# JONES & BEACH ENGINEERS INC.

**RE: Response Letter- TRG Meeting Comments  
120 Marketplace Boulevard, Rochester, NH  
Tax Map 216, Lot 11  
JBE Project No. 21173**

# MIXED USE BUILDING "RIDGE MARKETPLACE"

A202

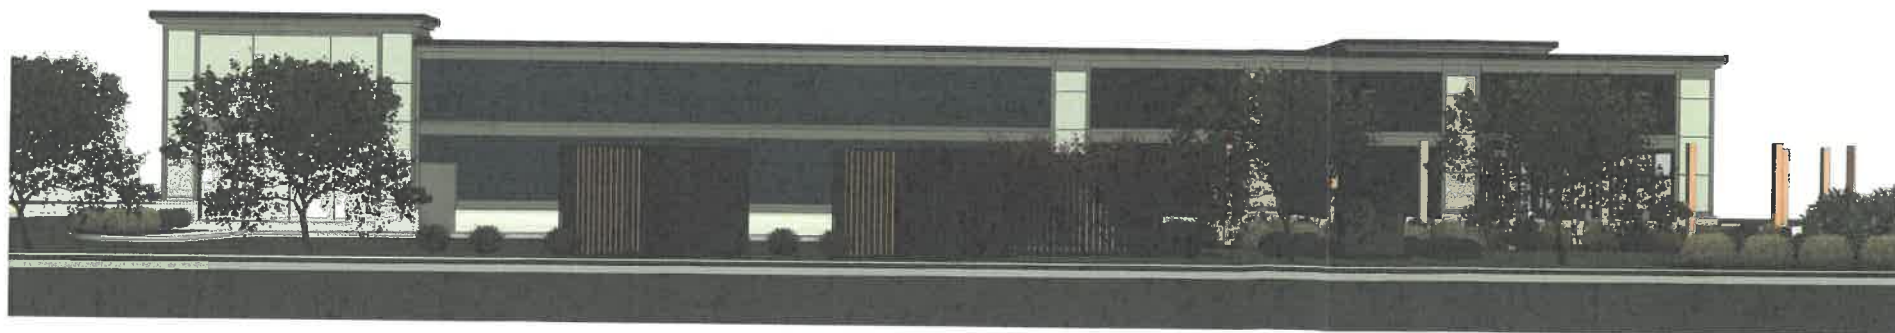
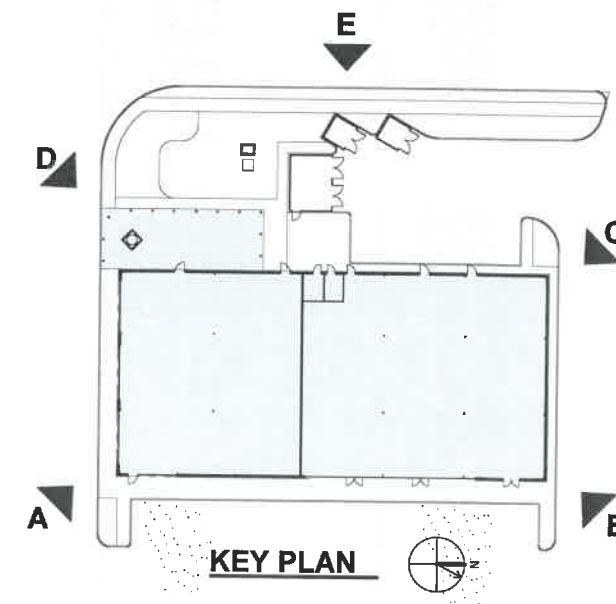
- b. *Please show a rendering perspective from Market Place Blvd. This is considered a double frontage lot and a front façade style is required for both sides. It's understandable that you have limited space for things like dumpsters but those and utilities will need to be well screened and the façade treatment should mimic the front where possible. Please also show the awning or roof structure planned for the outdoor dining section.*

**RESPONSE:** See attached additional perspectives showing the Market Place Blvd. Elevation with proposed landscape shown. The Façade treatment along Market Place Blvd. is consistent with the overall building façade design knowing that this façade faces a main road. On this elevation there is a corner tower for the retail space along this elevation and the restaurant façade wraps this corner that opens up to the patio space.
